32ND AVENUE (HIGHLANDS CREEK BLVD TO TAH PARKWAY) AT THE AURORA HIGHLANDS

OVERALL SITE PLAN

32ND AVENUE (HIGHLANDS CREEK BLVD TO TAH PARKWAY)
AT THE AURORA HIGHLANDS
GRADING & UTILITY PLAN

SITE PLAN TRACKING CHARTS

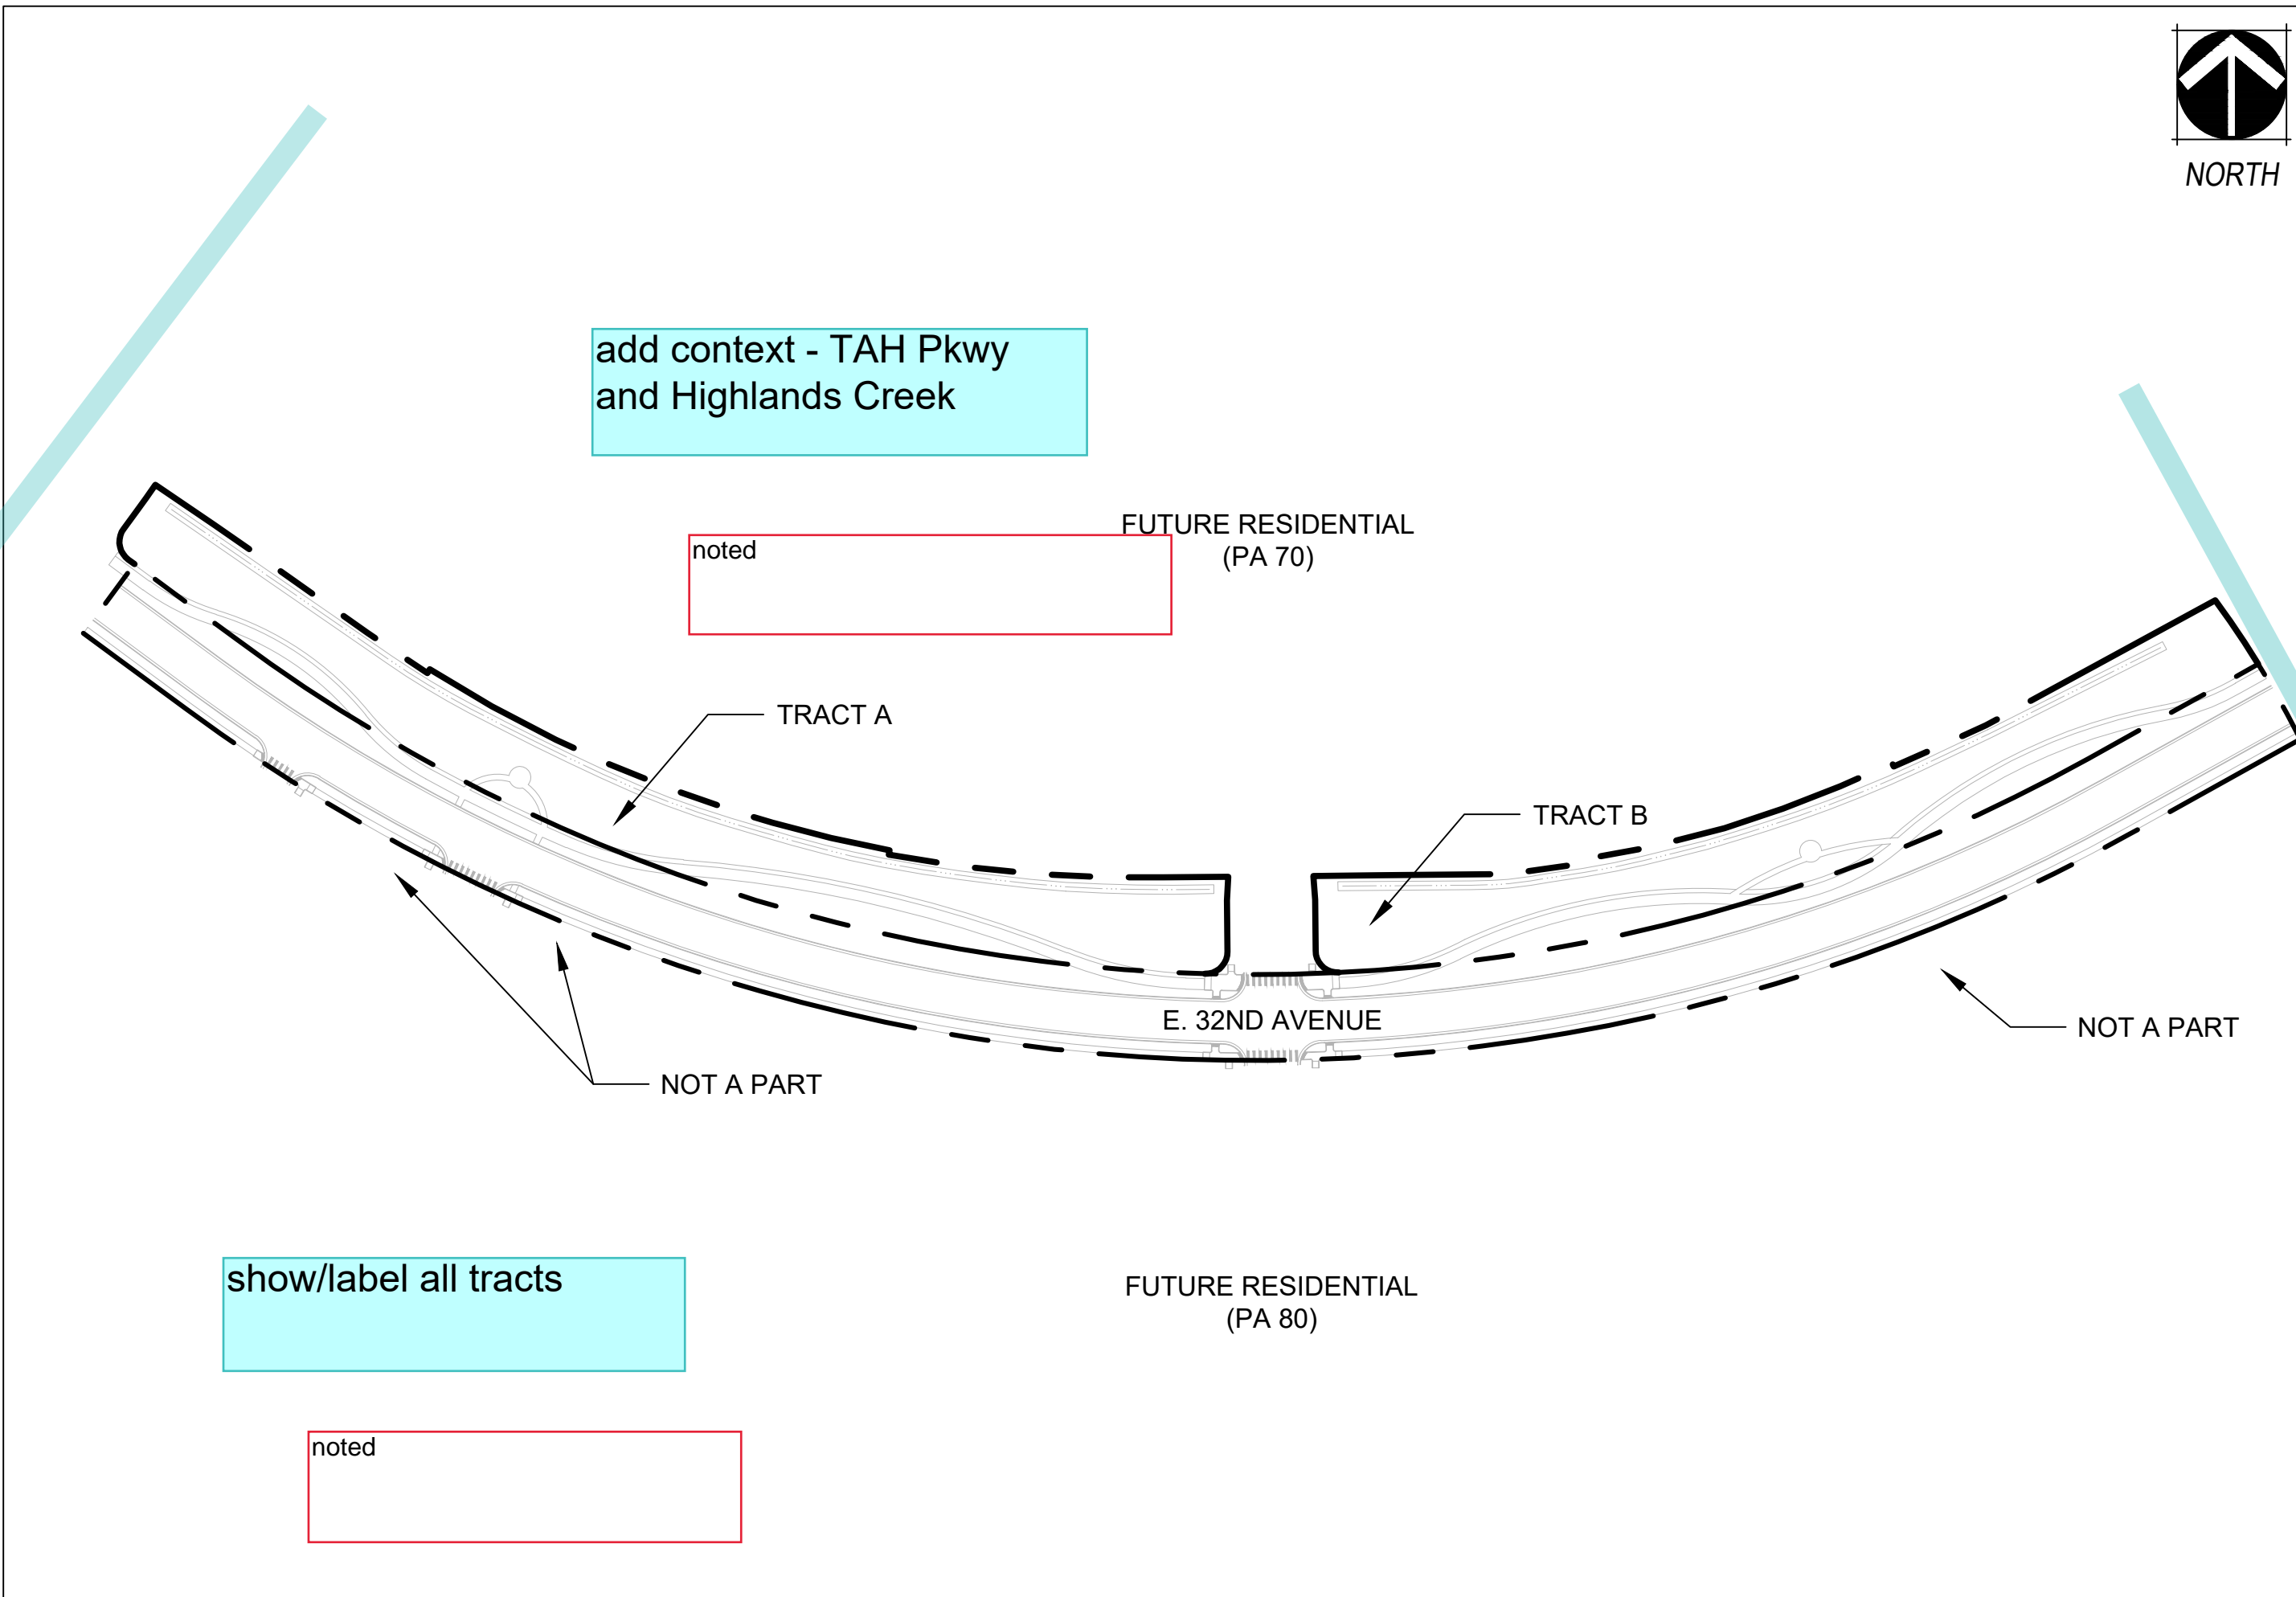
no lots in Flg 11

Noted

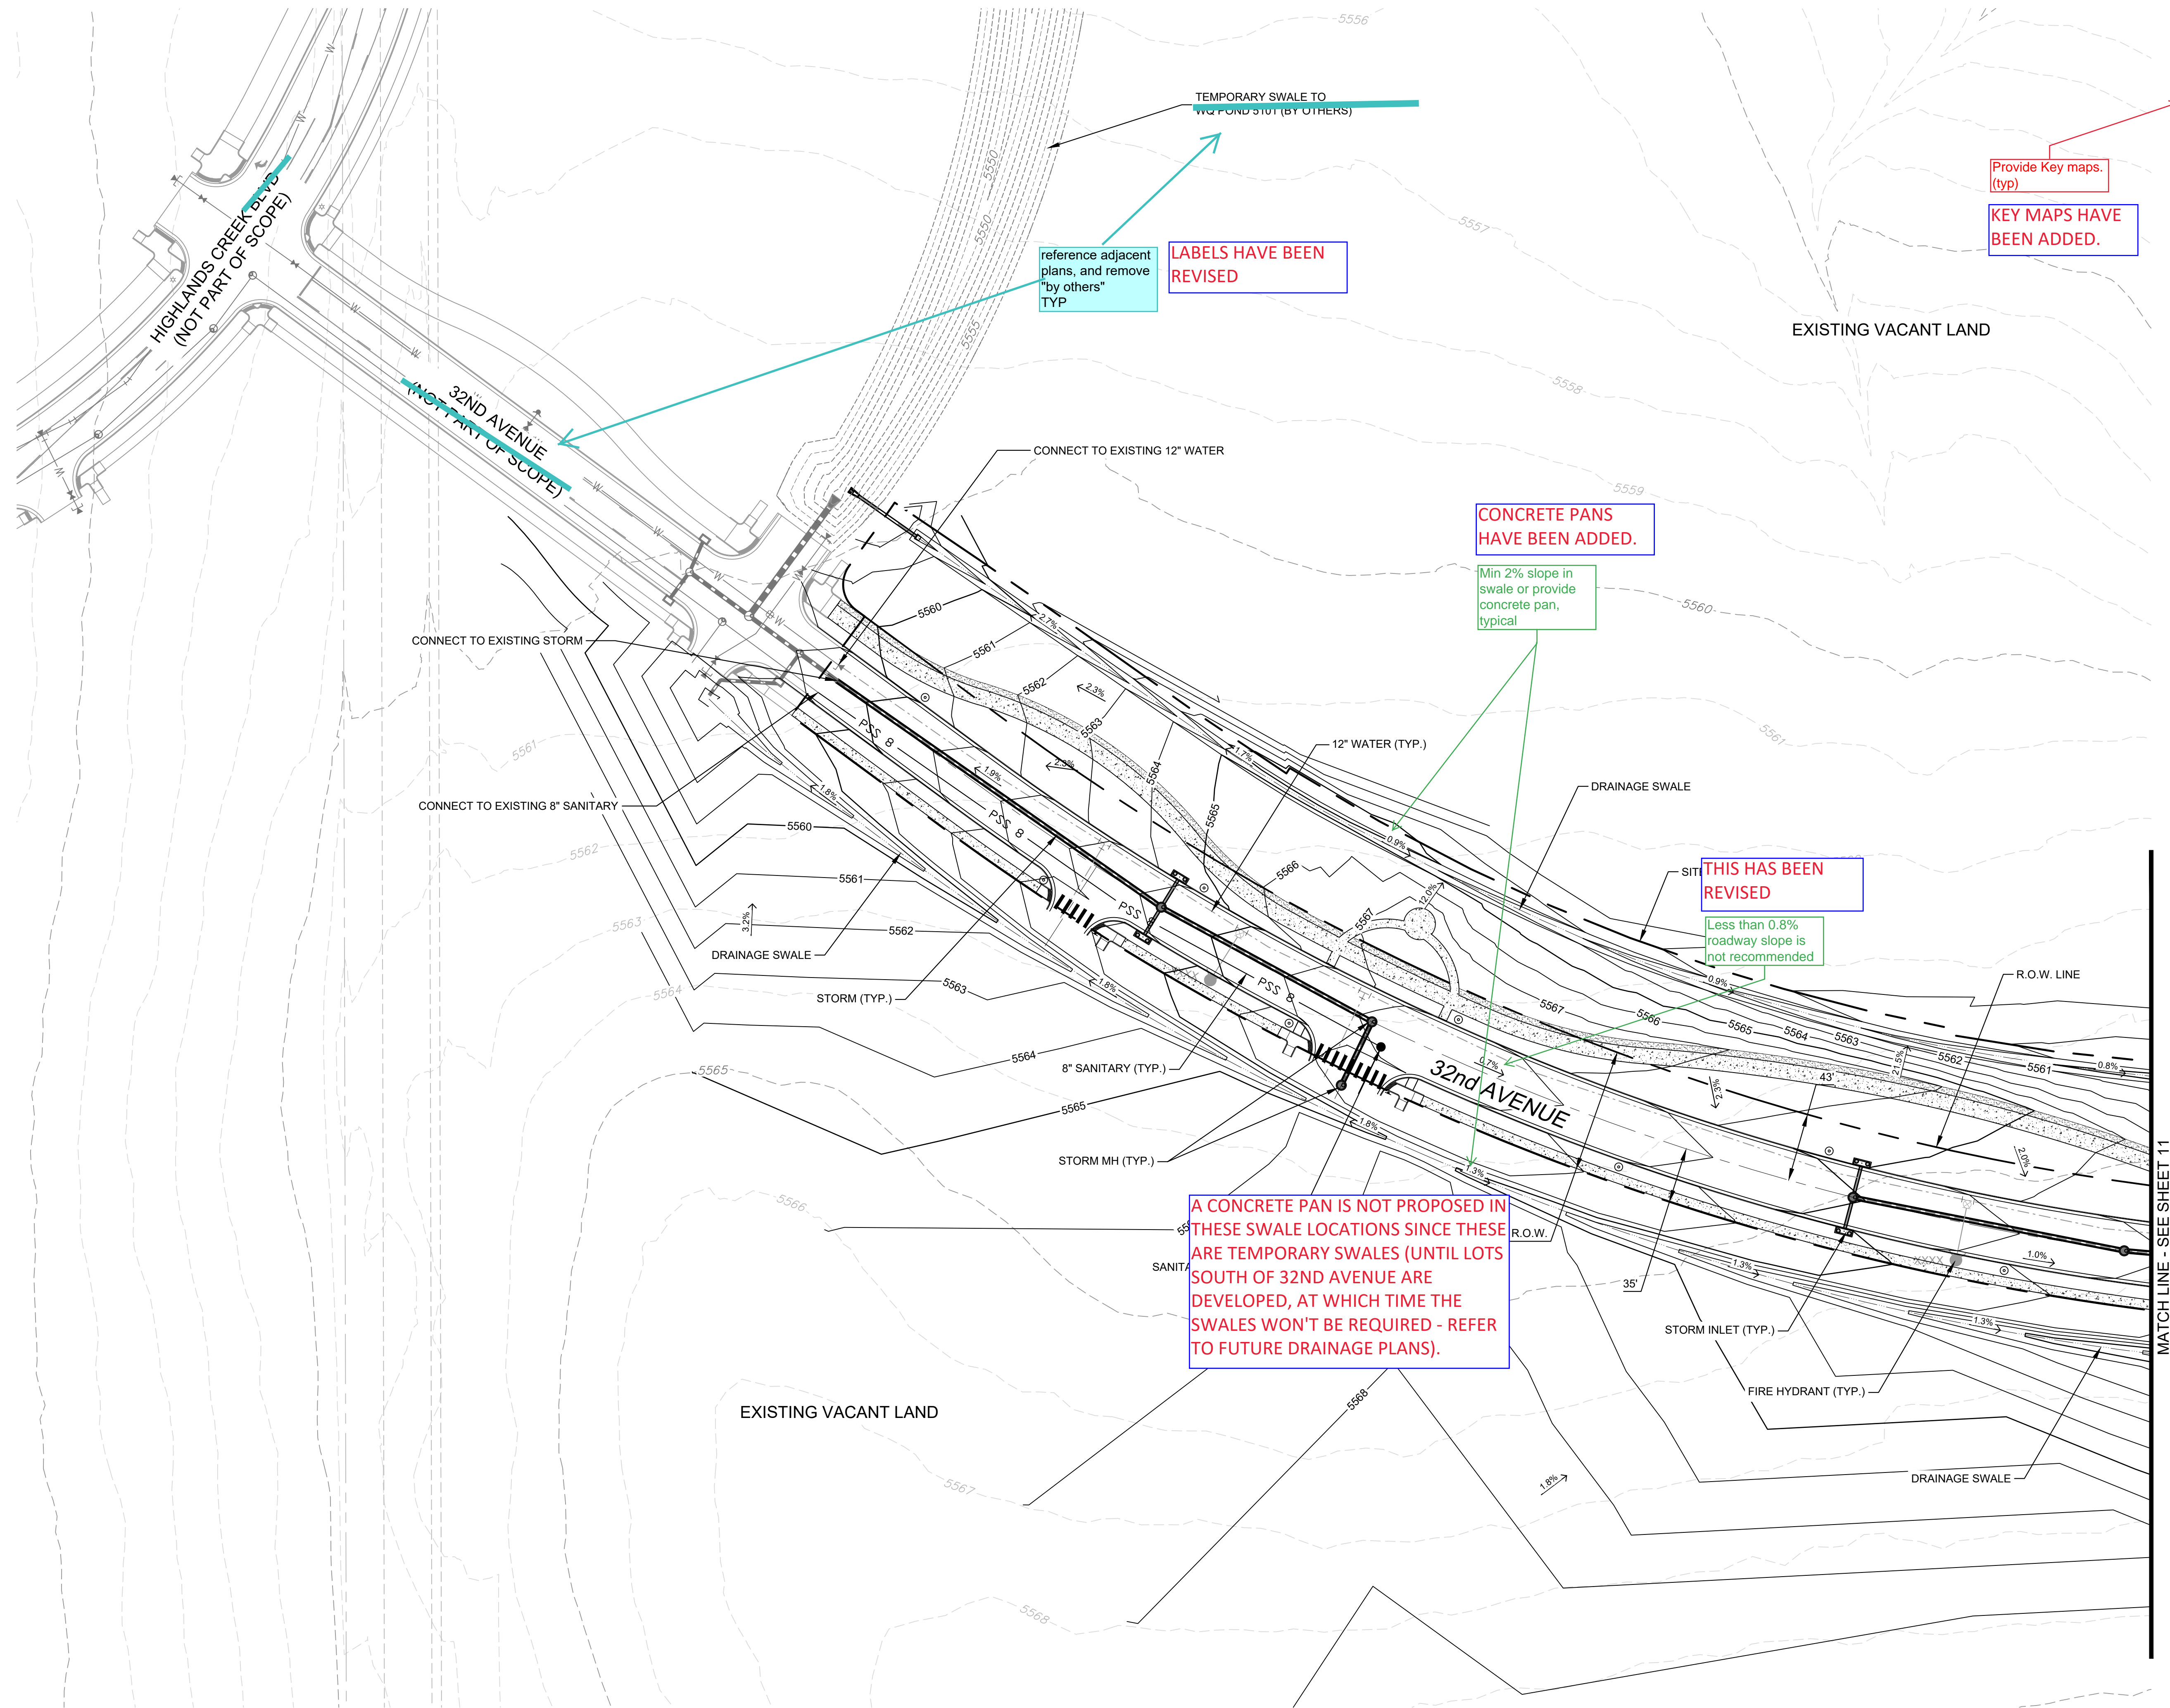
Add a note indicating if the storm sewer system is public or private and who will maintain it.

Plans should not be less than 1"=50'

A NOTE HAS BEEN ADDED

SCALE BAR WAS INCORRECT - THIS HAS BEEN REVISED

ENGINEERING & UTILITY PLAN

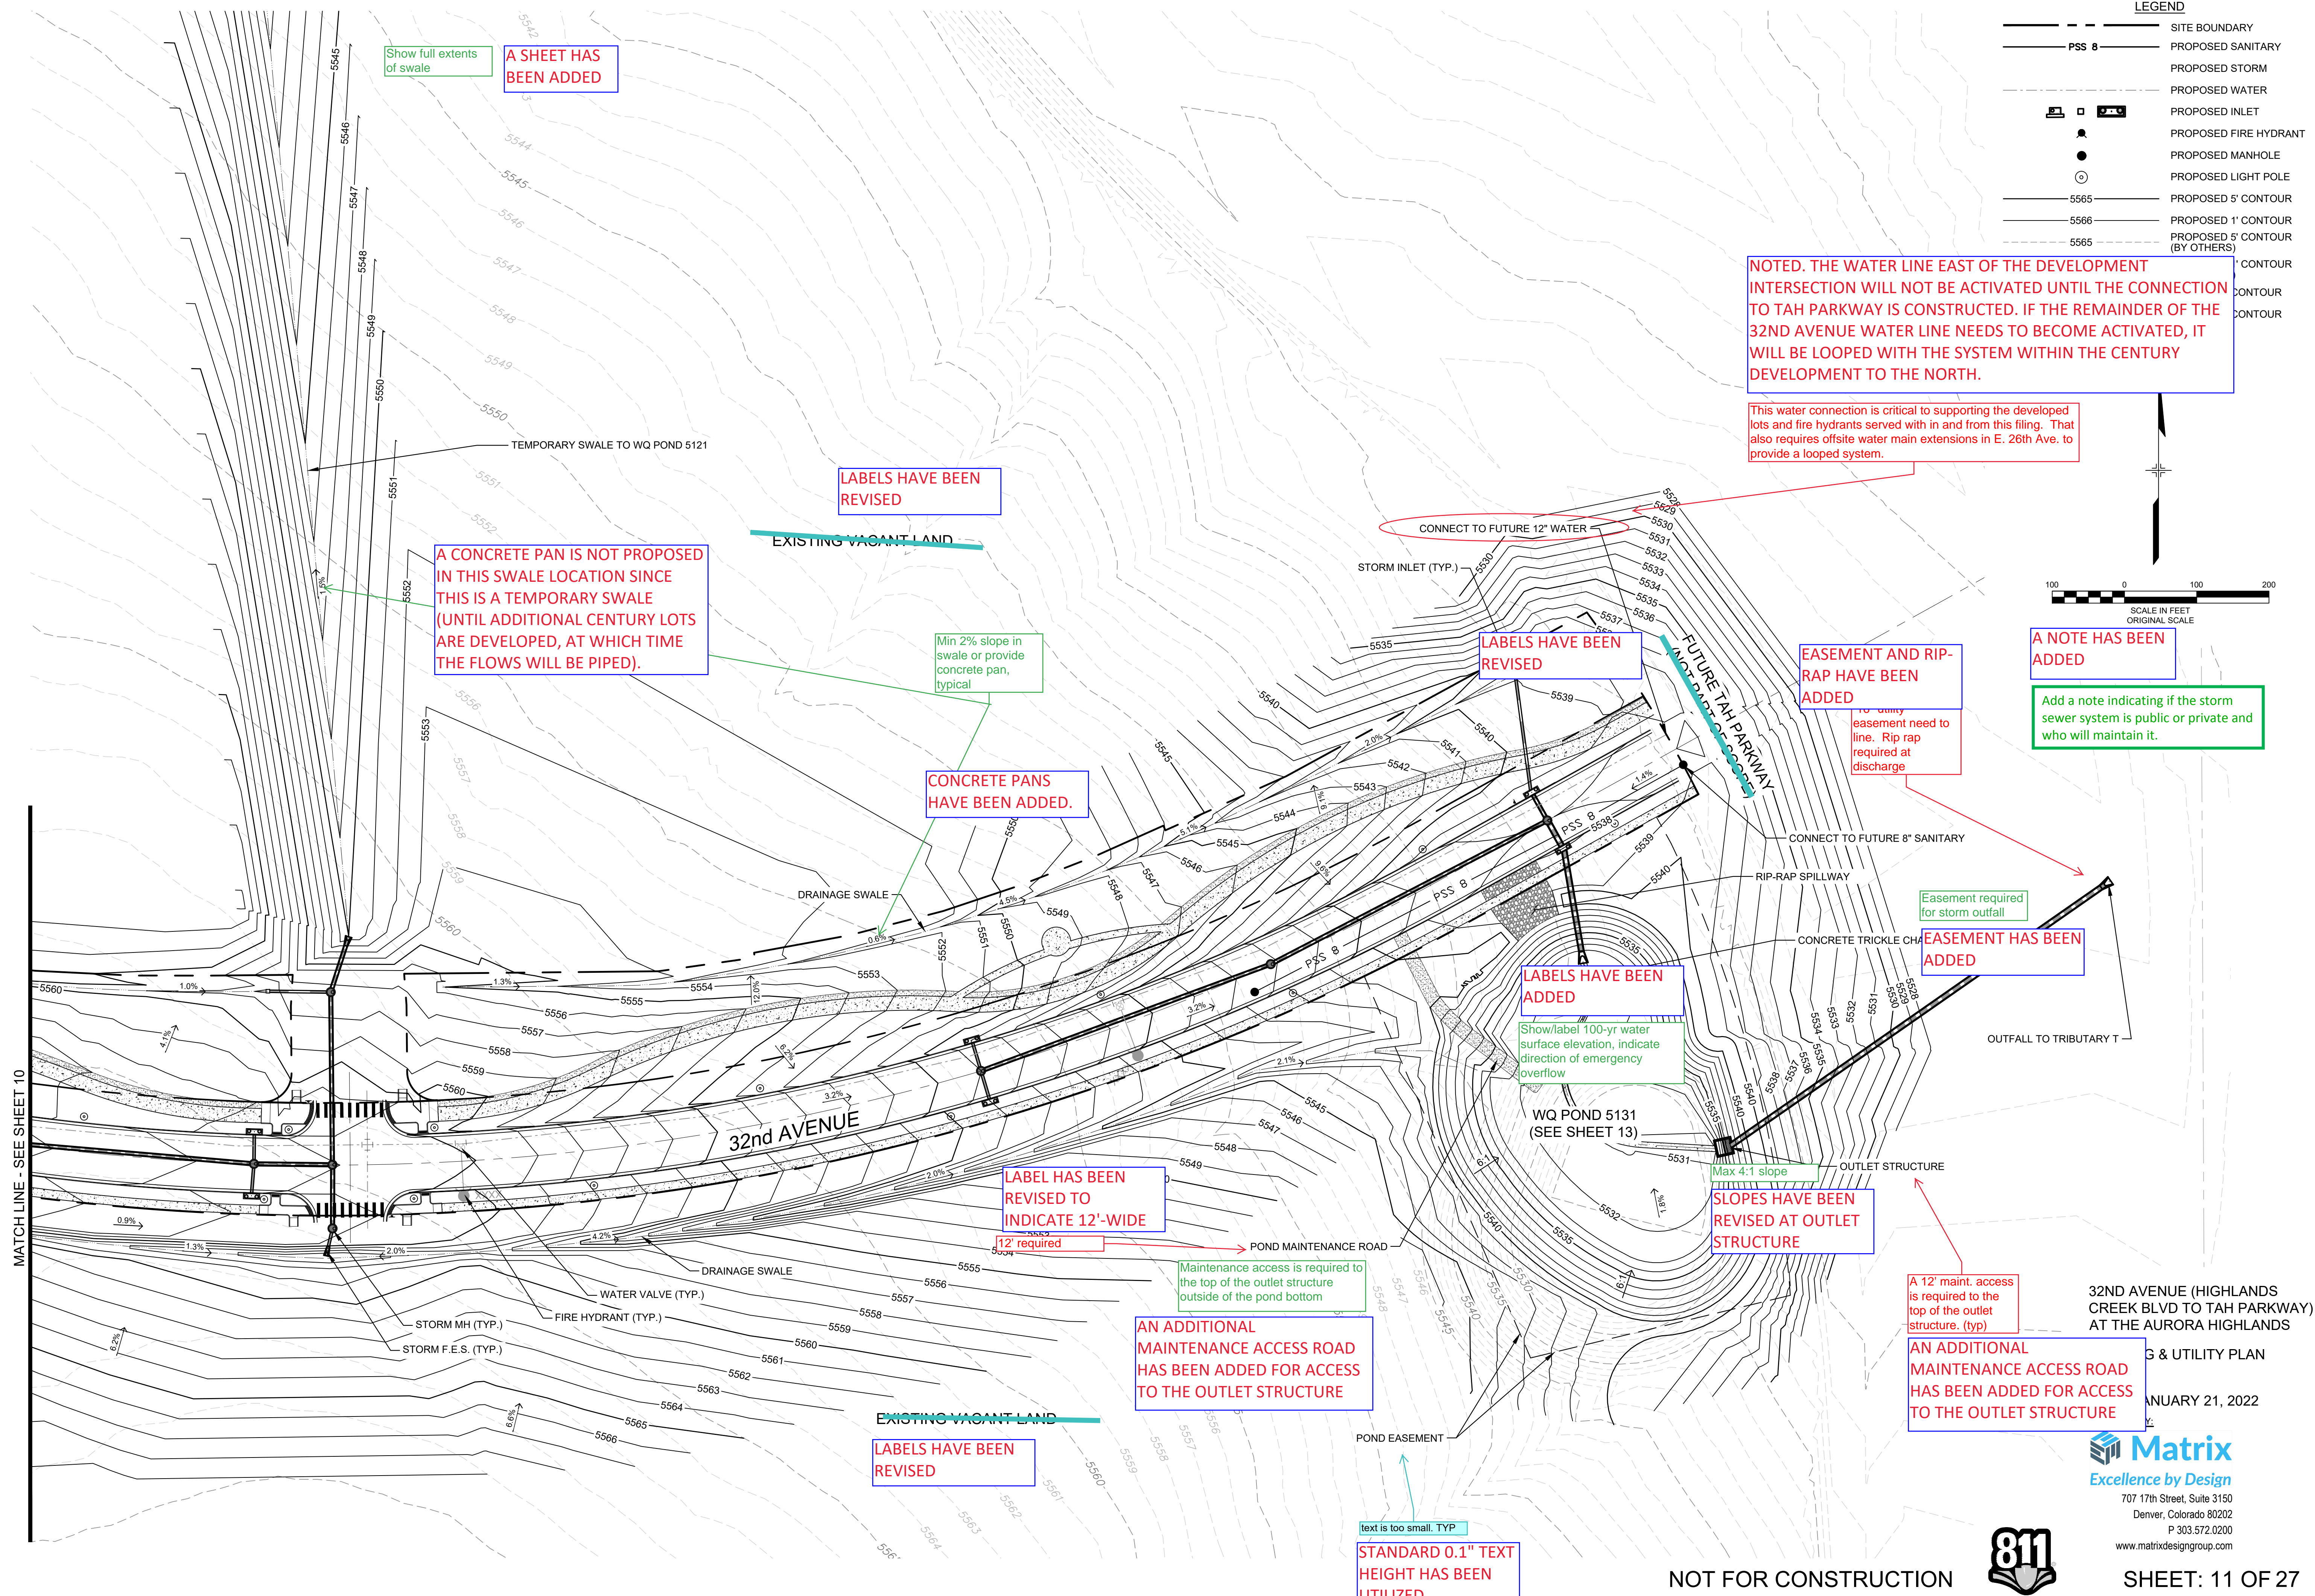
Add a note indicating if the storm sewer system is public or private and who will maintain it.

This water connection is critical to supporting the developed lots and fire hydrants served with in and from this filing. That also requires offsite water main extensions in E. 26th Ave. to provide a looped system.

to army easement need to line. Rip rap required at discharge

Easement required for storm outfall

A 12' maint. access is required to the top of the outlet structure. (typ)

A NOTE HAS BEEN ADDED

NOTED. THE WATER LINE EAST OF THE DEVELOPMENT INTERSECTION WILL NOT BE ACTIVATED UNTIL THE CONNECTION TO TAH PARKWAY IS CONSTRUCTED. IF THE REMAINDER OF THE 32ND AVENUE WATER LINE NEEDS TO BECOME ACTIVATED, IT WILL BE LOOPEO WITH THE SYSTEM WITHIN THE CENTURY DEVELOPMENT TO THE NORTH.

EASEMENT AND RIP-RAP HAVE BEEN ADDED

EASEMENT HAS BEEN ADDED

SLOPES HAVE BEEN REVISED AT OUTLET STRUCTURE

AN ADDITIONAL MAINTENANCE ACCESS ROAD HAS BEEN ADDED FOR ACCESS TO THE OUTLET STRUCTURE
